# County of Santa Clara

**Subject: 2015 SMARA Inspection Report for the Permanente Quarry  
County Planning Office File 2250-15PAM  
State Mine ID #91-43-0004**

**RE: 2015 SMARA MINE INSPECTION  
CPO FILE 2250-13-66-09PAM (PERMANENTE ROAD)  
PERMANENTE QUARRY, 91-43-0004  
CUPERTINO, CALIFORNIA**

Photo 6: Portion of re-vegetated north-facing slope of WMSA, looking east. A portion of this slope will be removed in Phase 2 to backfill of North Quarry. Dated September 3, 2015.

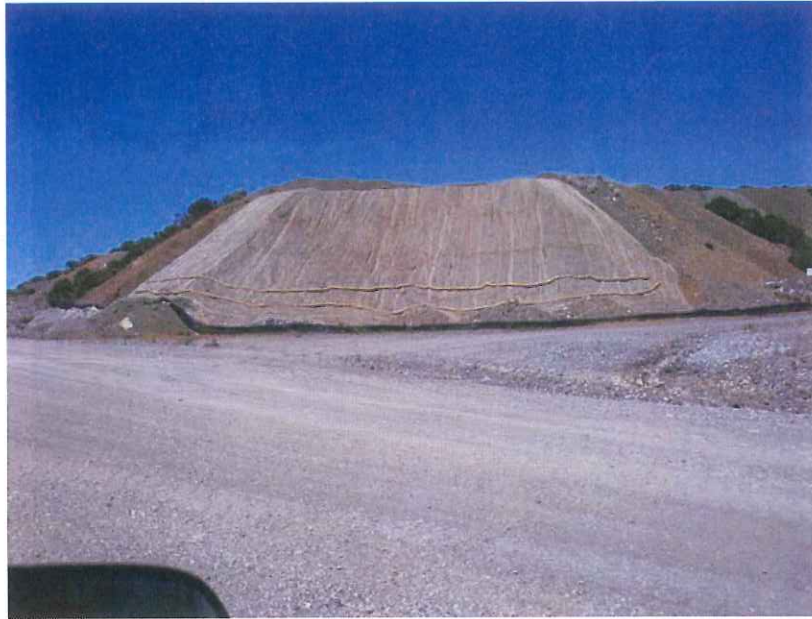
for later use in reclamation of Permanente Creek. Both of the WMSA topsoil stockpiles continue to be signed. Beginning around 2021 in Phase 2 of the RPA, approximately 48 million tons of overburden material from the WMSA including wash fines will be placed in the North Quarry to raise the final floor elevation to approximately 990 feet msl. Revegetation efforts along the northern WMSA were observed during the 2015 inspection (**Photo 6**).

Prior to the 2012 RPA, the 1985 Reclamation Plan allowed the overburden placed in the WMSA to remain in place with some final grading to create slopes at a gradient of 2.0H:1.0V or shallower. Recent grading and re-vegetation of the lower northern portions of the WMSA have been done to reduce the visual impact and control erosion (**Photo 6**). Portions of the current southern slopes of the WMSA about a portion of the mine that had been considered pre-SMARA. The 2012 RPA includes grading of the upper portion of this area to increase final slope stability of the WMSA and allow for proper drainage (see RPA Figure 3.16-14). During Phase 2 of reclamation, the WMSA northern fill slope will be excavated down to an elevation that daylight at approximately the current contact between the native vegetation and the revegetated area seen in **Photo 6**.

Photo 13: Silt fence BMP along outer edge of mid-slope bench in southern slope of WMSA required by regrading the roadway for the installation of groundwater monitoring wells. Dated September 3, 2015.

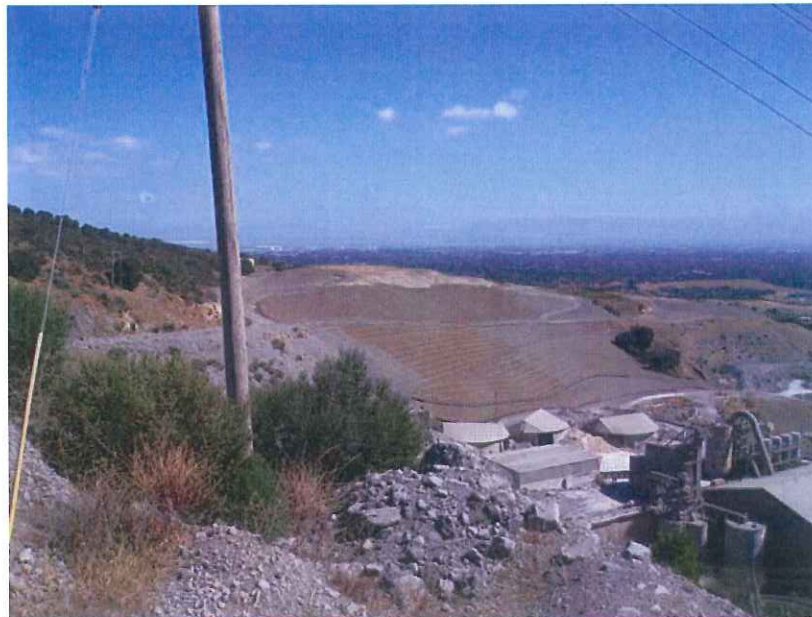
The western portion of the mid-slope bench was re-opened in 2015 to allow for installation of the groundwater monitoring wells required by the SFBRWQCB (**Photo 11**). Wire-supported silt fence and straw waddles have been placed along the re-graded road for stormwater management (**Photos 11, 12 and 13**). The drainage outfalls along this mid-slope bench roadway should continue to be monitored as part of the site's stormwater management. County staff should continue to observe the roadway before the end of November as part of the pre-winter inspection.

2. The perimeter slopes of the WMSA and EMSA rock storage piles should continue to be monitored for erosion control and modified, as necessary.
3. The mitigation measures implemented to control runoff from the road running mid-slope south of the WMSA should be monitored and modified, as necessary.

Photo 22: New primary crusher looking north. Drainage sump in foreground. Dated September 3, 2015.

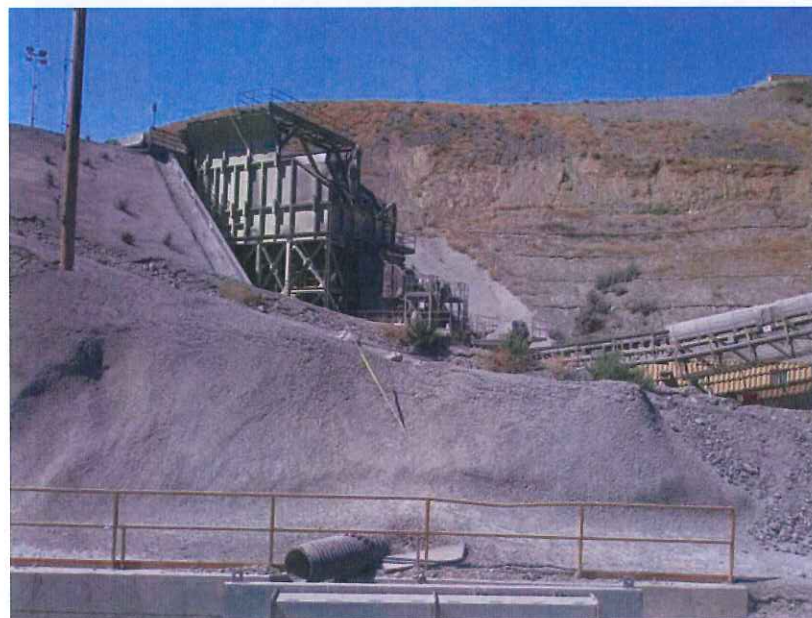
The new crusher area has changed the topography from that shown in the 2012 RPA (see 12-15-11 Engineering Drawing Details sheet 12 of 13). The RPA doesn't address how the new crusher area will be reclaimed. In discussion with the operator, they haven't determined the final reclamation grades in the new crusher area. Will the retaining wall for the primary crusher be removed or left in place to stabilize the reclaimed slope? Will the excavation be backfilled and sloped to conform to the topography shown in the approved reclamation plans, or will it remain excavated? The operator should determine the final reclamation topography for the new crusher area and provide the County with a report and grading maps. Determination of the new crusher area's final reclamation may require an analysis of the slope stability, in particular whether the retaining walls for the new crusher should remain in place or be removed. The FACE should then be revised as appropriate to reflect the costs of reclaiming the new crusher area.

Photo 26: Looking northwest at the lower portion of washed out slope caused by overflow of the new crusher sump in December 2014. Dated September 3, 2015.

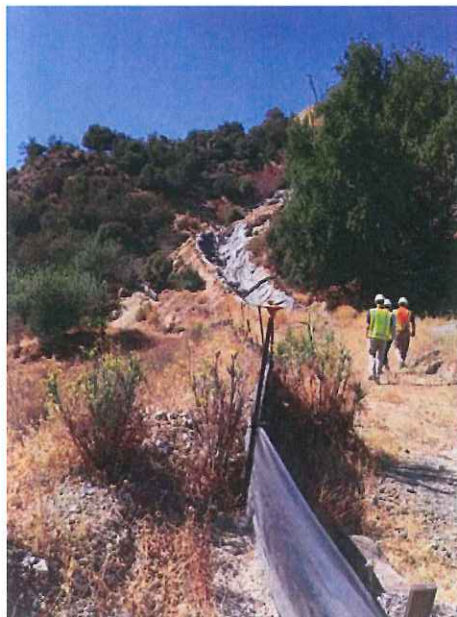
i) Slopes – Working (max./current)			
ii) Slopes – Reclaimed			
<b>4) Erosion Control</b>	a) Oct. 22, 2012 SWPPP; RPA 3.9 b) RPA Appendix F - Chang, 12/12/2012 c) RPA Appendix B - WRA 12/2011; RPA 3.18, 3.19; COAs 68 to 70; 78 to 81	BMPs and stormwater management program is active and winterization is proceeding. See attached inspection rpt. for comments on Crusher slope washout.	<input type="checkbox"/>
